SUBJECT: Decatur Airport  
Decatur, Illinois  
Macon County  
Illinois Project Number: DEC-4822  
SBG Project Number: N/A  
Contract No. DE084  
Item No. 09A, January 19, 2024 Letting  
Addendum A

## NOTICE TO PROSPECTIVE BIDDERS

**RECONSTRUCT SELECT PORTIONS OF THE AIRPORT TERMINAL ENTRANCE ROAD**

**PATCHING DETAILS**

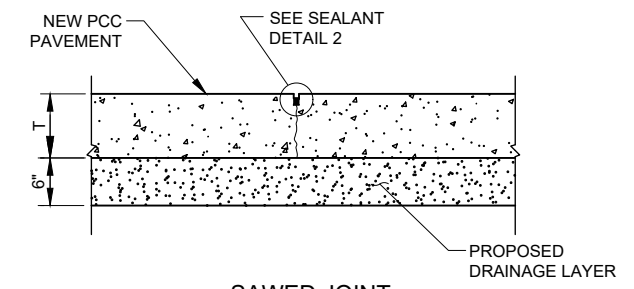
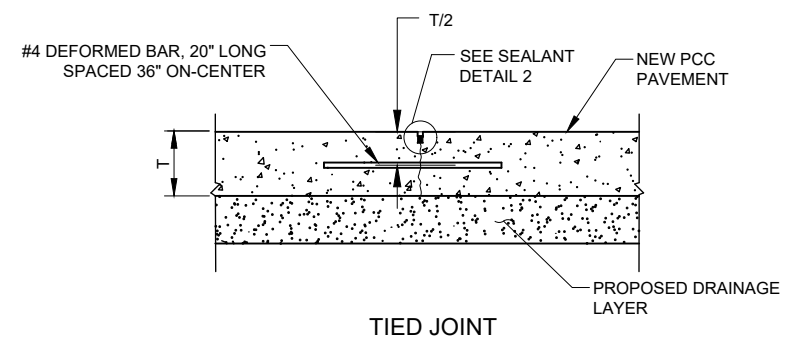
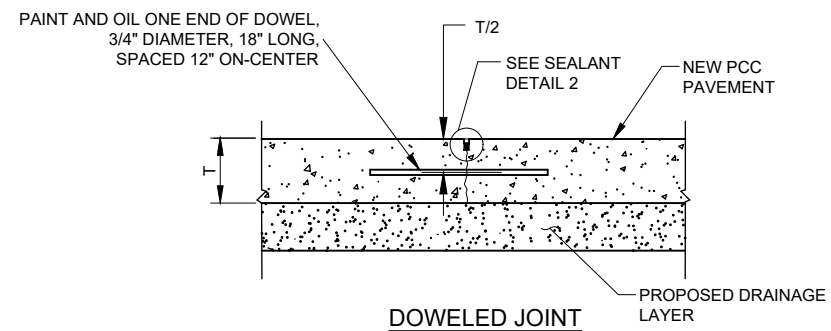
This addendum includes a modification to the jointing notes on sheet 6 of the plan set.

1. JOINT SPACING SHALL MATCH EXISTING.
2. TRANSVERSE JOINTS SHALL BE SAWED JOINTS.
3. LONGITUDINAL JOINTS SHALL BE ALTERNATING SAWED AND TIED JOINTS.
